# Access Compliance Report

## Public Rights-of-Way

Intersection ID: 24358	Main Street: CASHEL_CT	Cross Street: PRESCOTT_POND_LN	Location: E
ADA ID: 991AF3229975	Ramp Type: BlendTrans1	Initial Pass/Fail: Pass	Overall Compliance: No
		Severity Score: 10.25

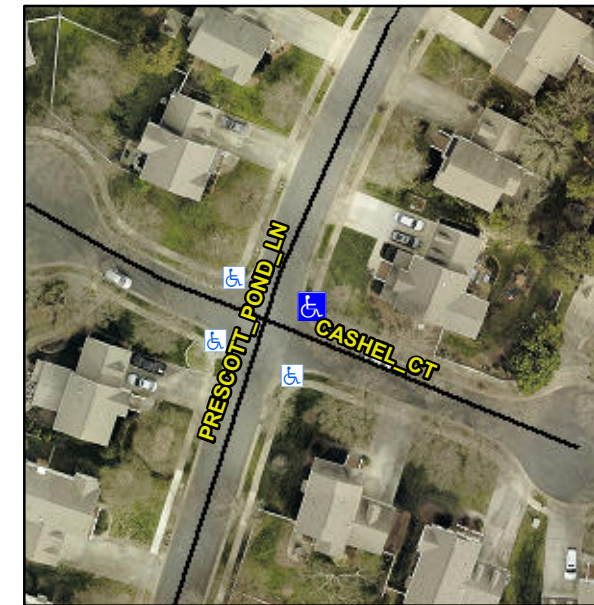
**Not Found, R304.5.3, R304.2.2-Perp, R304.3.2-Para, R305**

Compliance	Description	Data	Compliance	Description	Data
N/A	Ramp Length (in)	45.0	Yes	BlendTrans Slope (%)	3.2
Yes	Ramp Width (in)	55.0	No	BlendTrans XSlope (%)	3.1
N/A	Flare Type LT	Sloped	N/A	Flare Type RT	Sloped
N/A	Flare Slope LT (%)	2.0	N/A	Flare Slope RT (%)	5.0
N/A	Flare Traversable LT?	No	N/A	Flare Traversable RT?	No
Yes	Landing Length (in)	50.0	No	DWS Provided?	No
Yes	Landing Width (in)	55.0	N/A	DWS Contrast?	No
No	Landing Slope (%)	2.5	N/A	DWS Length (in)	N/A
Yes	Landing X Slope (%)	0.9	N/A	DWS Full Width?	No
N/A	Landing Curb? (Y/N)	No	N/A	DWS Offset (in)	N/A
N/A	Shared Landing?	No			
Yes	Gutter Ponding?	No	Yes	Gutter Slope (%)	4.0
Yes	Gutter Lip Ht (in)	0.0	Yes	Gutter X Slope (%)	0.7
N/A	Painted X Walk1?	No	N/A	Painted X Walk2?	No
	X Walk 1 Direction	To NW		X Walk 2 Direction	To SW
	X Walk 1 Width (in)	N/A		X Walk 2 Width (in)	N/A
	X Walk 1 Slope (%)	2.0		X Walk 2 Slope (%)	1.8
	X Walk 1 X Slope (%)	0.3		X Walk 2 X Slope (%)	2.1

N/A	Ramp inside XWalk1?	N/A	N/A	Ramp inside XWalk2?	N/A
	Road Slope (%)	0.8		Clear Space?	Yes
	Road X Slope (%)	0.4	N/A	Clear Space to XWalk (in)	N/A
Yes	Any Obstructions?	No	Yes	Storm Grate/Utility Hazard?	No
	Obstruction Type			Storm Grate/Utility Type	
		N/A			N/A
			Yes	Surface Condition? (G/P)	Good
			No	Curb Slope (%)	19.5

**Remove & Replace Curb Ramp With Two New Directional Ramps or Equivalent.**
